Hydrogeologic Report on the
Federal Marine Terminals Property
Riverview, Michigan
TDD# F5-8007-5C

Region V
FIT Performance Evaluation Form

Facility Name and Location: SASF/FMT, RIVERVIEW, MICHIGAN

This evaluation is for the following FIT activity: CONDUCT AN INITIAL
hydrogeologic field study OF THE FEDERAL MARINE TERMINALS
PROPERTY, RIVERVIEW, MICHIGAN

PLATE 3

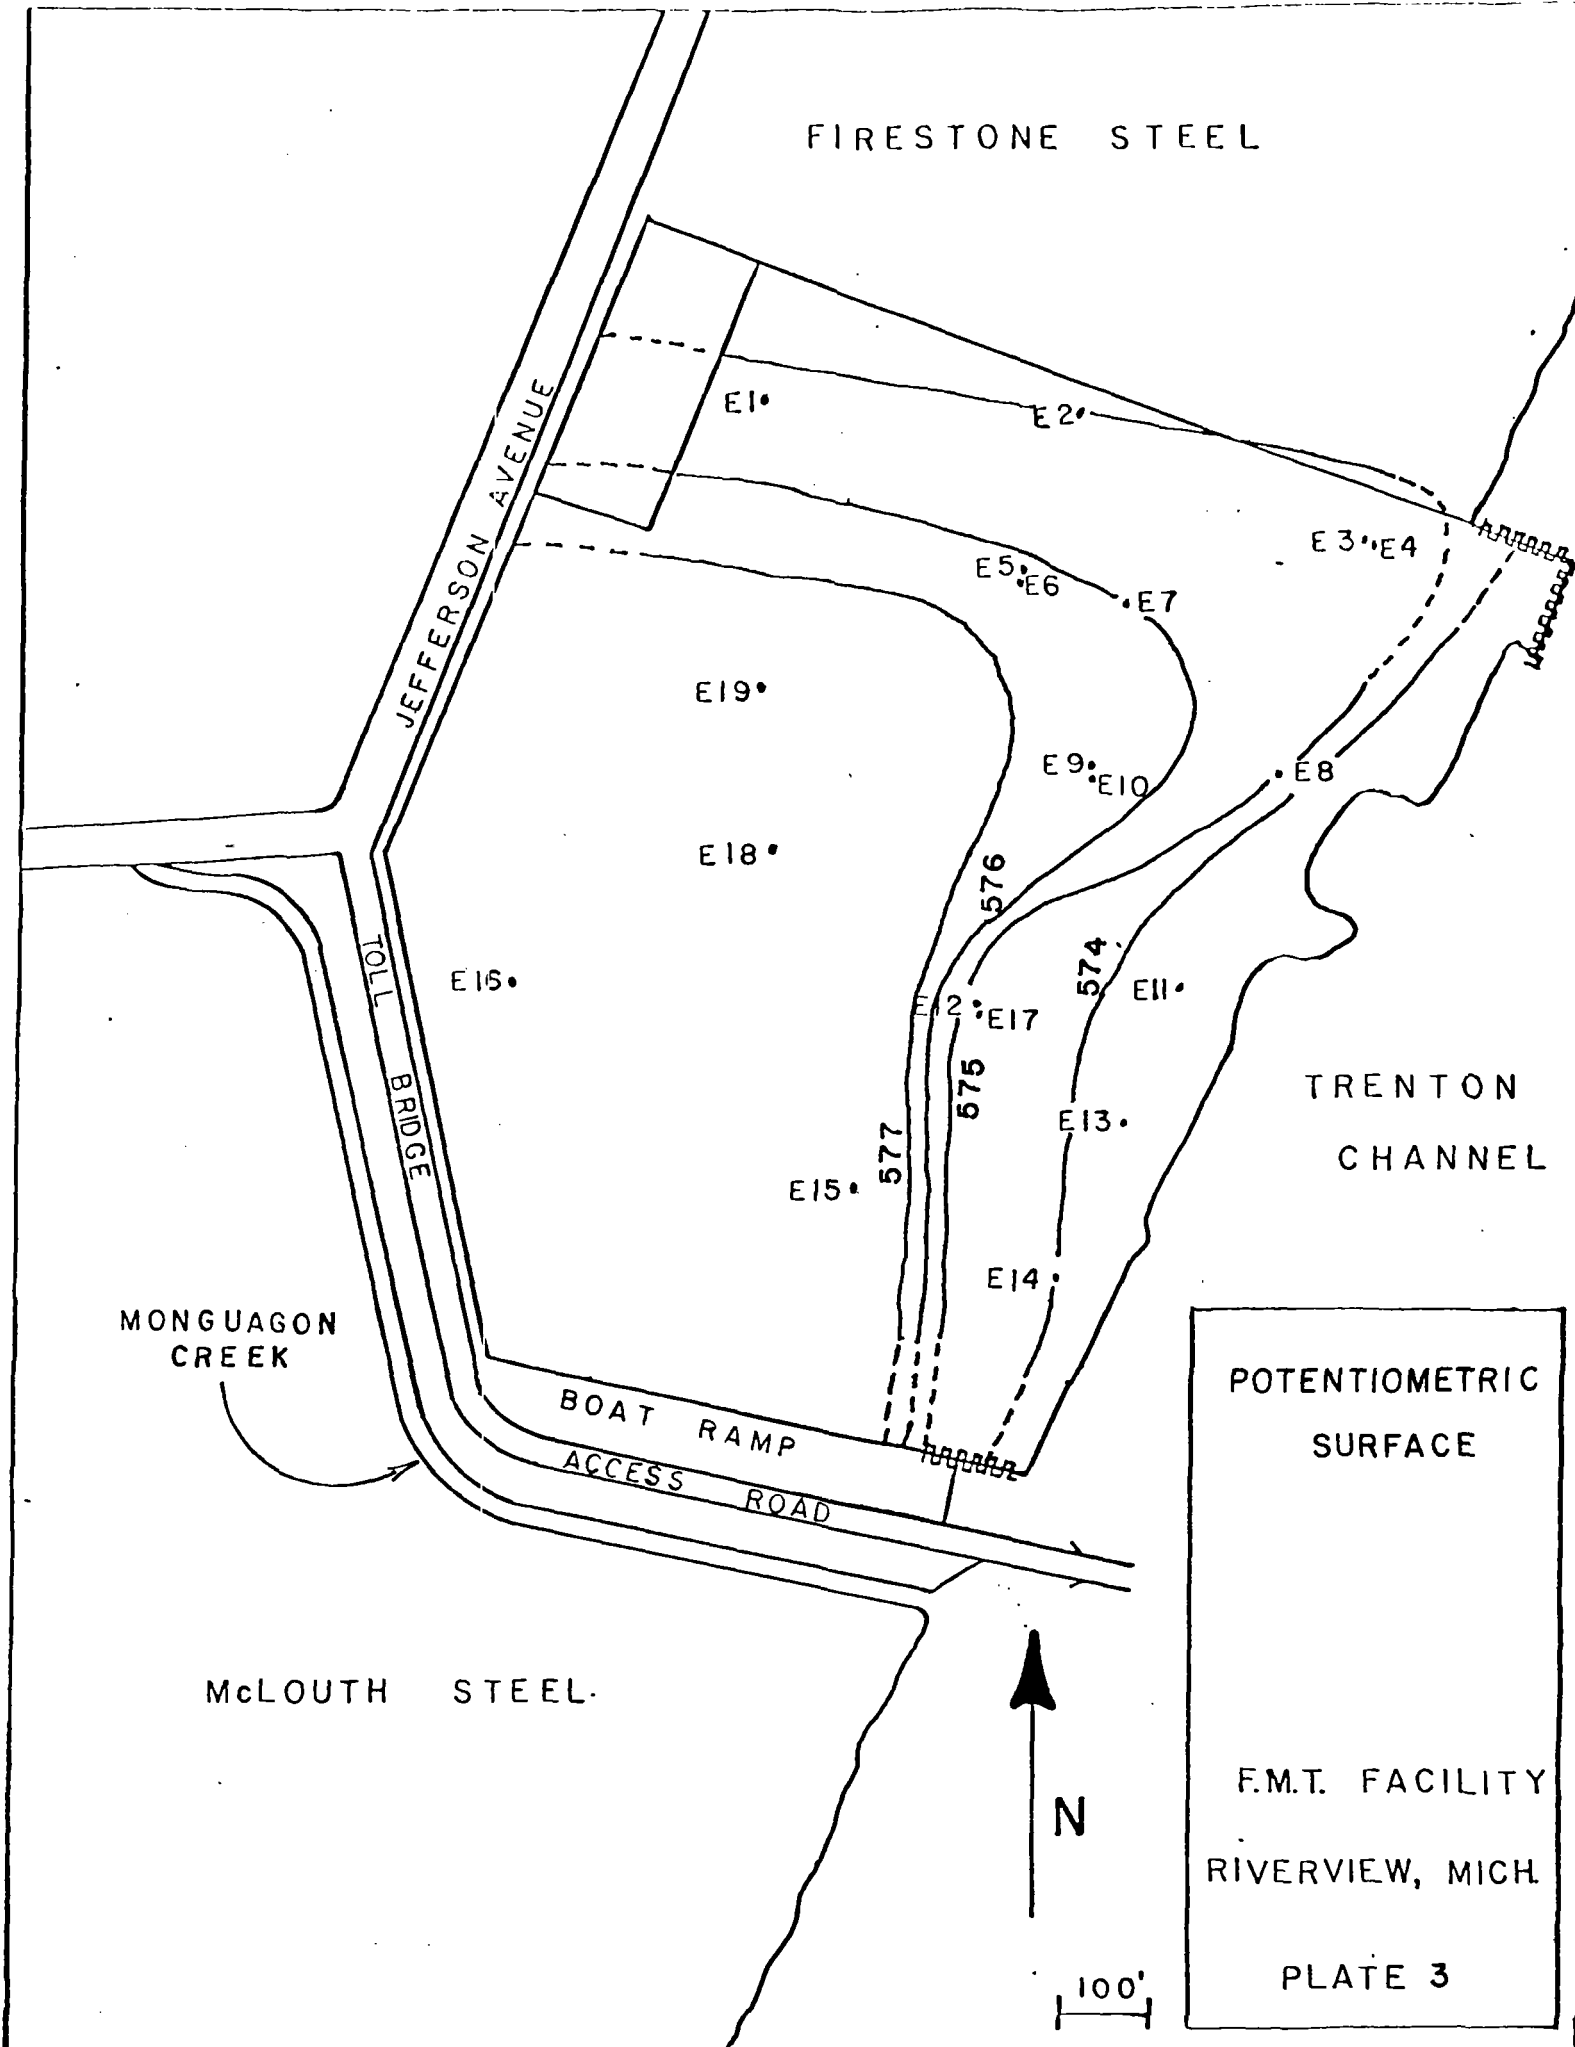
OK
relate
to
conclusion
O.C.
